St. Barbara_M2004-013 TR3 Adequacy Review Response

Please accept this response to Adequacy Review No. 2 for Technical Revision No. 3 for the St. Barbara Quarry (M2004-013)

**Re: Pete Lien & Sons, Inc.; Mining Permit No. M-2004-013; St. Barbara Sand and Gravel Mine;
Technical Revision Request to increase acreage disturbed.**

St Barbara Pit

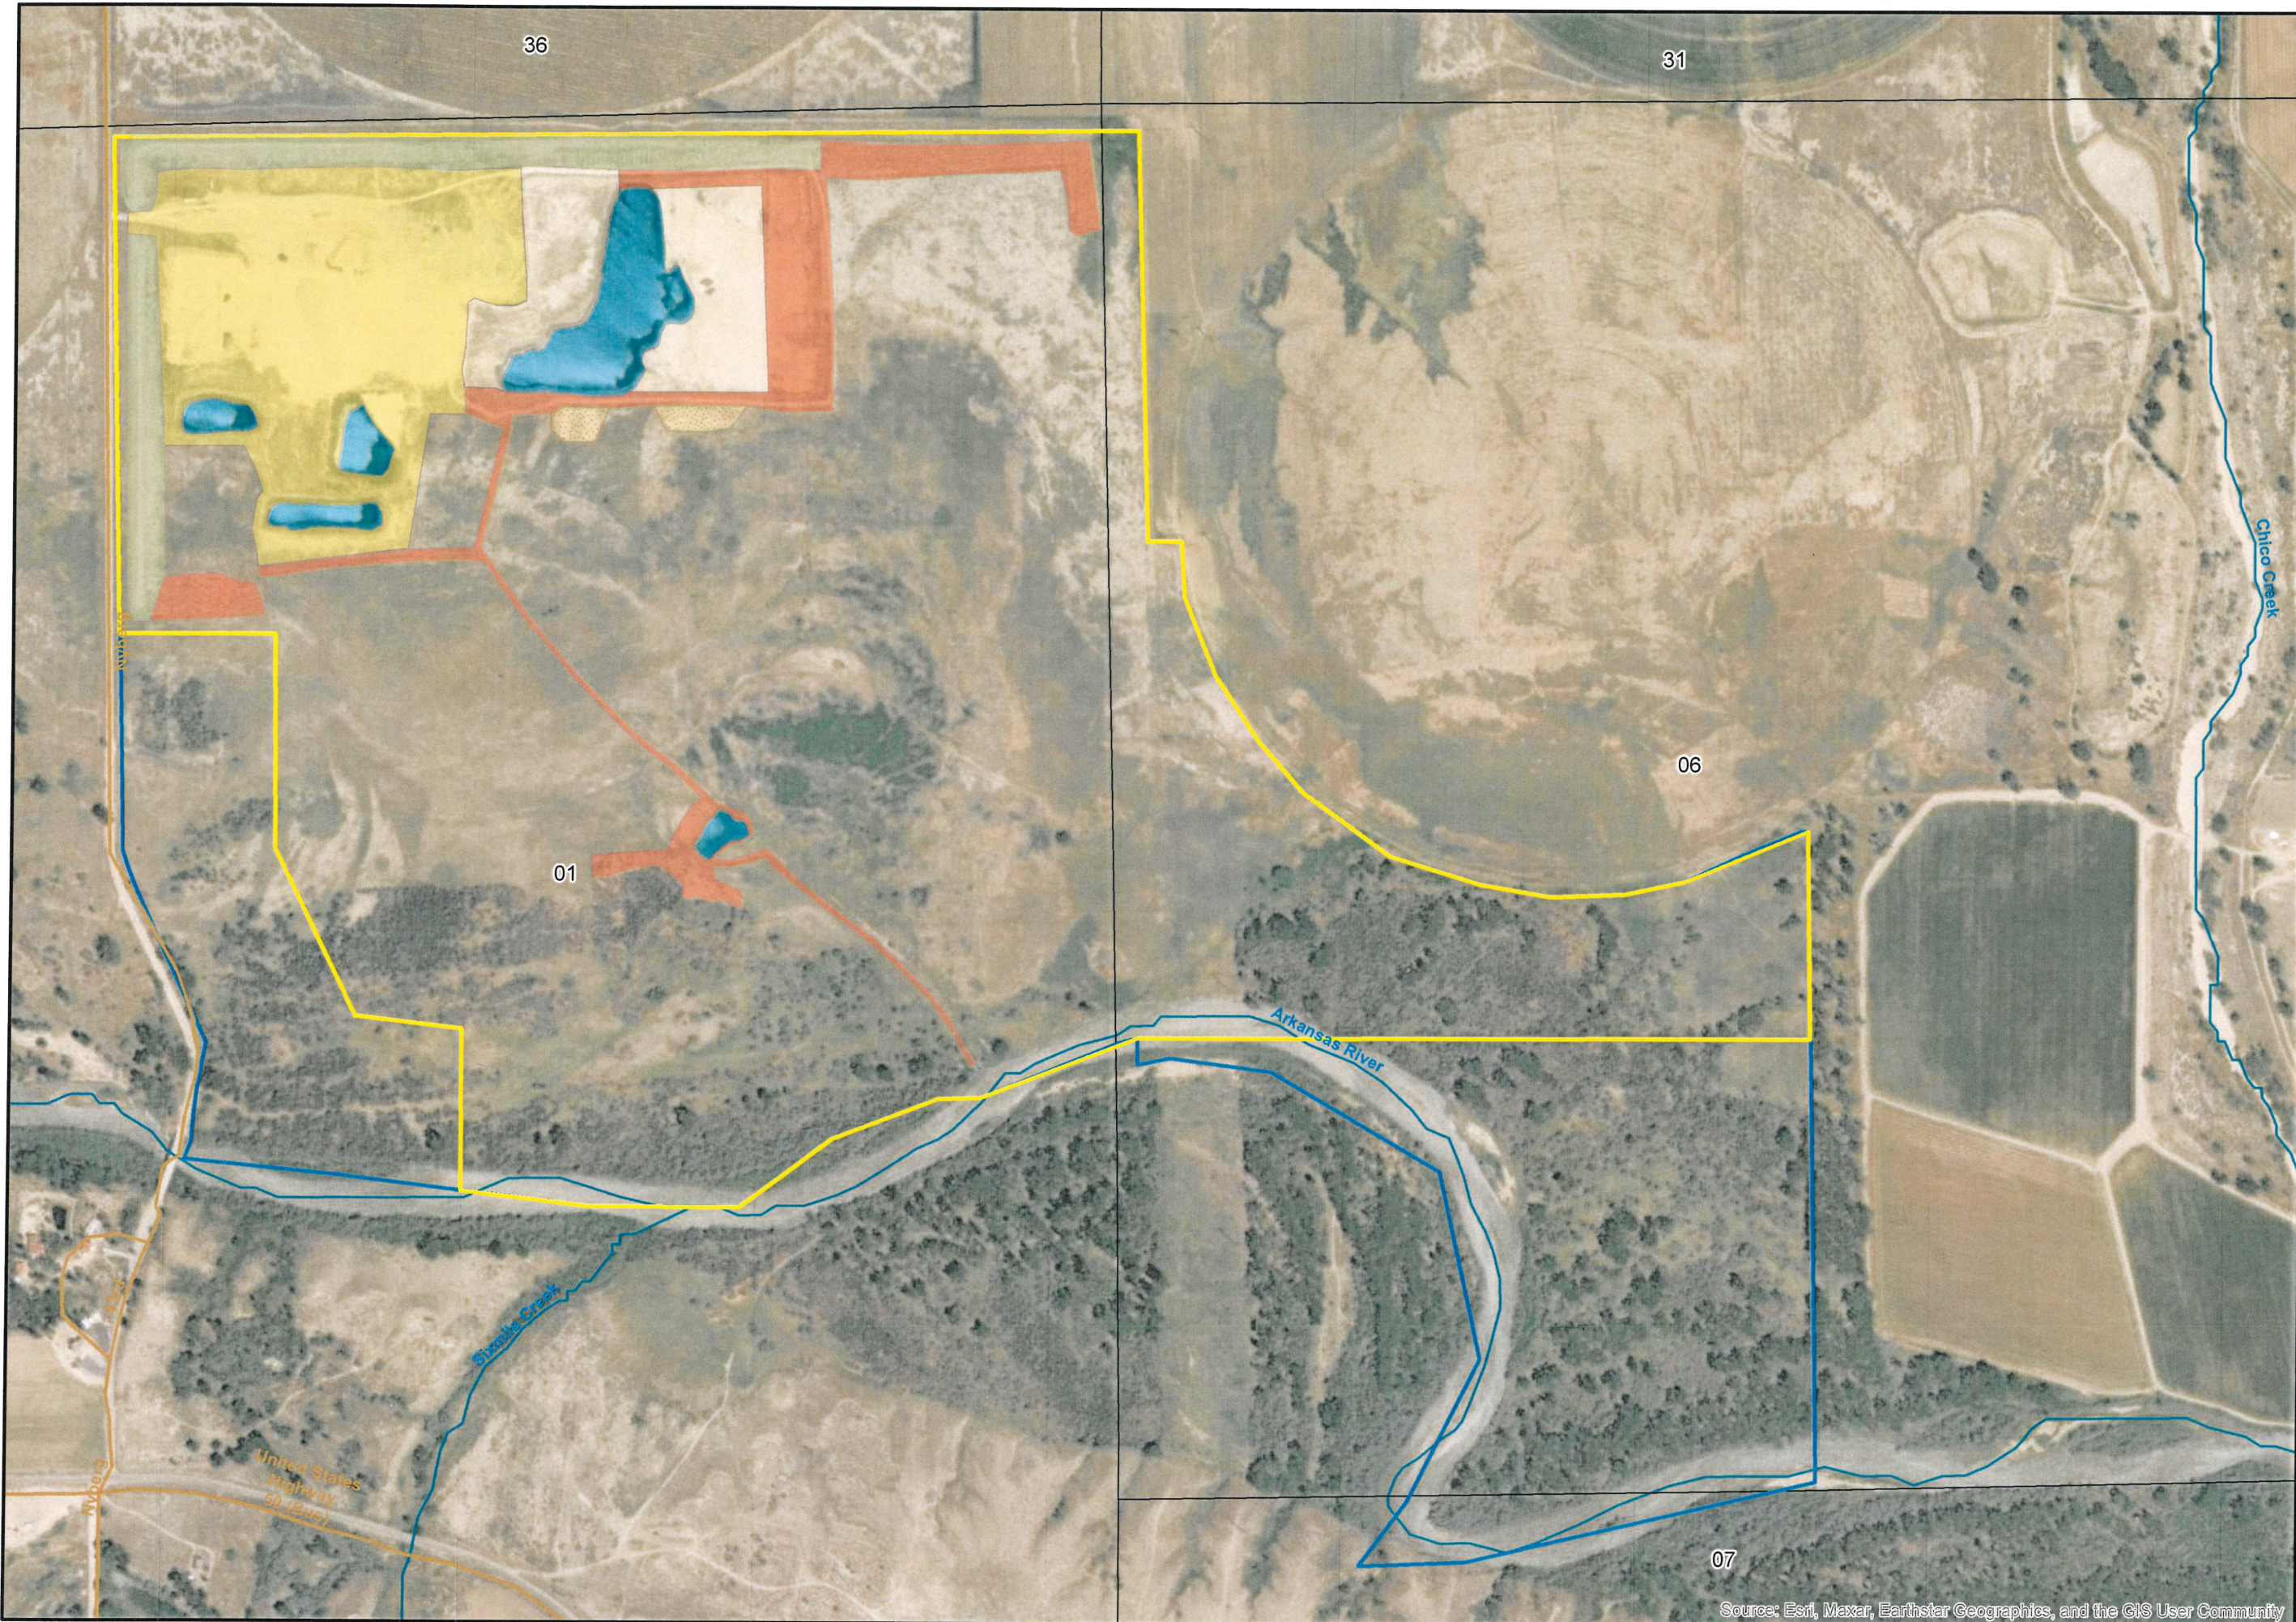
Item 2. Please clarify where the 13.0 acres that currently have topsoil and have been reseeded are located.

Item 5. Submitted map that shows an area of 23.4 acres labeled “St. Barbara Quarry-Pond”. Clarify the discrepancy between backfilling pond areas and disturbed land.

- The map has been revised to show the area where topsoil has been placed and has been seeded. These areas were mistakenly identified as topsoil stockpiles whereas they are actually existing berms. These berms were initially identified on Exhibit C-3.
- Two Topsoil Stockpiles, now located south of the quarry pond and identified on the map, will be used to reclaim the backfilled area, north-west of the quarry pond during the next period of activity in the quarry.

- It was not our intention to imply that 23.4 acres would be the size of the pond. The updated map with this response now identifies ponds that will require backfilling separately. The amount of exposed water based on our review is currently 9.26 acres which is within the 9.76 acres allowed within the current Substitute Water Supply Plan (SWSP ID 4695, WDID 1407803). Therefore, it would not be necessary to update the SWSP.

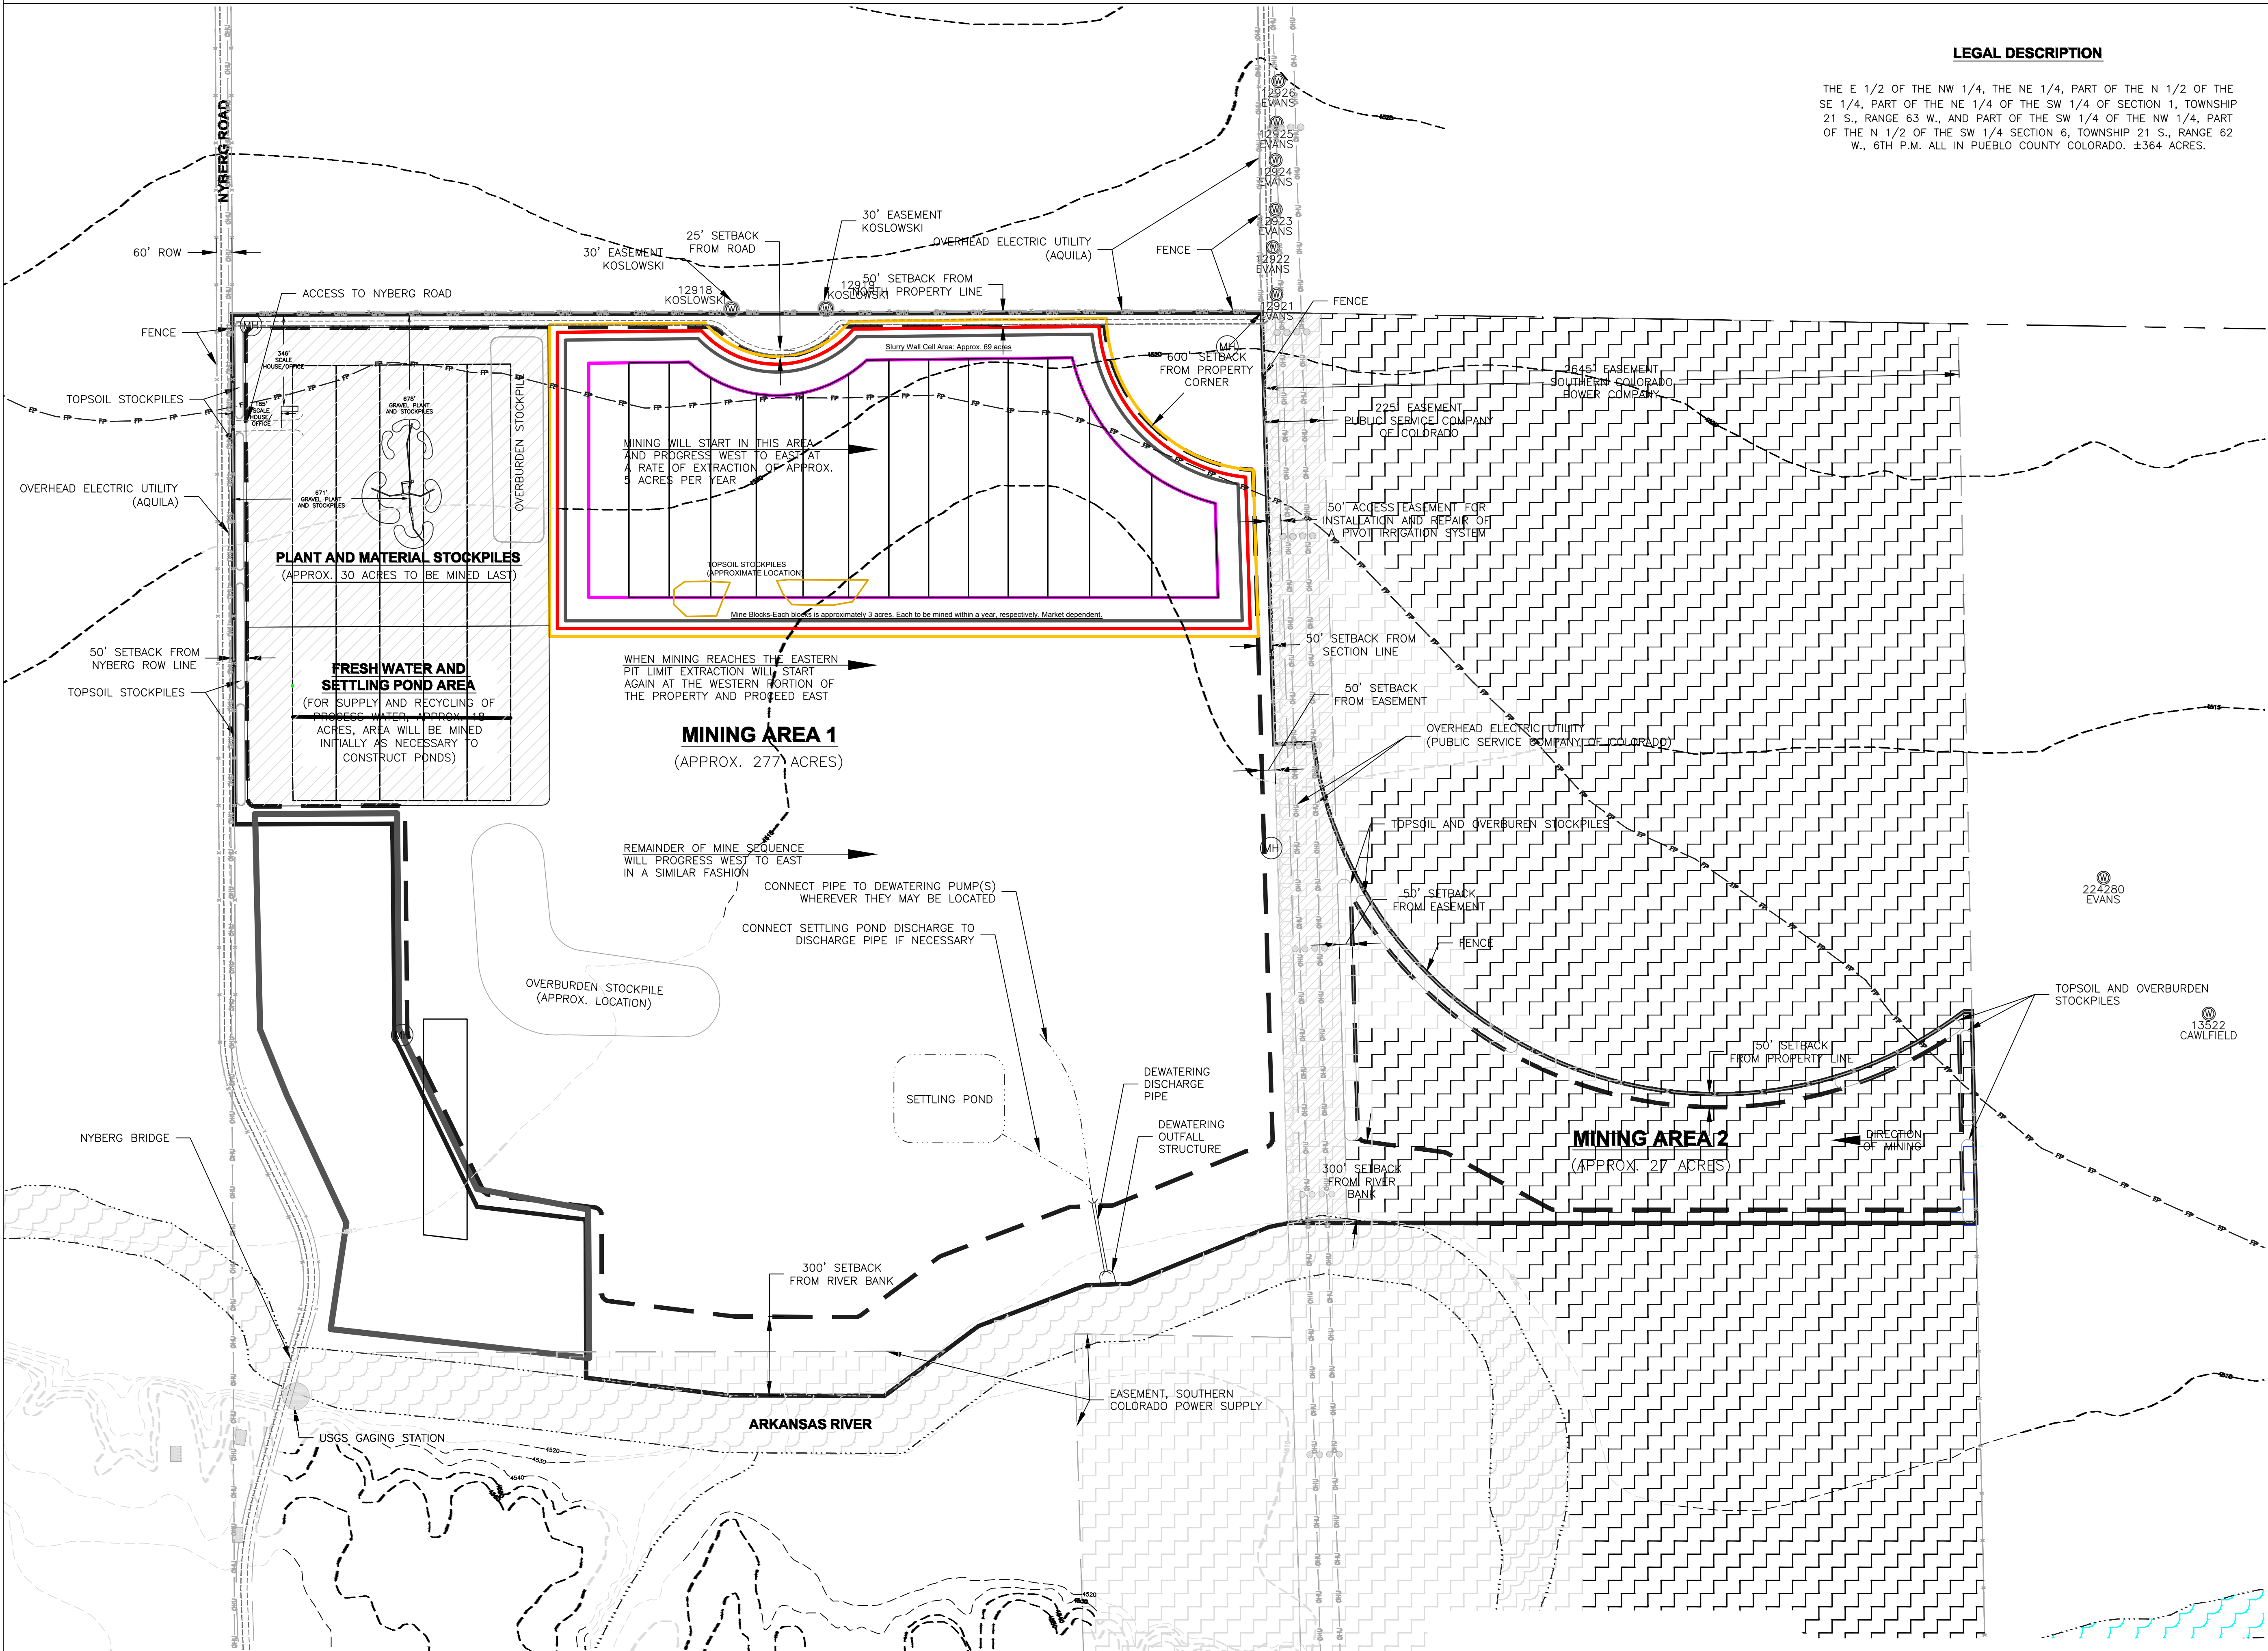
Item 7. Exhibit C-3, Mining Plan Map: Additional Topsoil Stockpile Locations

- Two additional Topsoil Stockpile locations have been added to Exhibit C-3, Mining Plan Map, to show the approximate location of additional stockpiles. These topsoil stockpiles currently contain approximately 10,000 cubic yards.
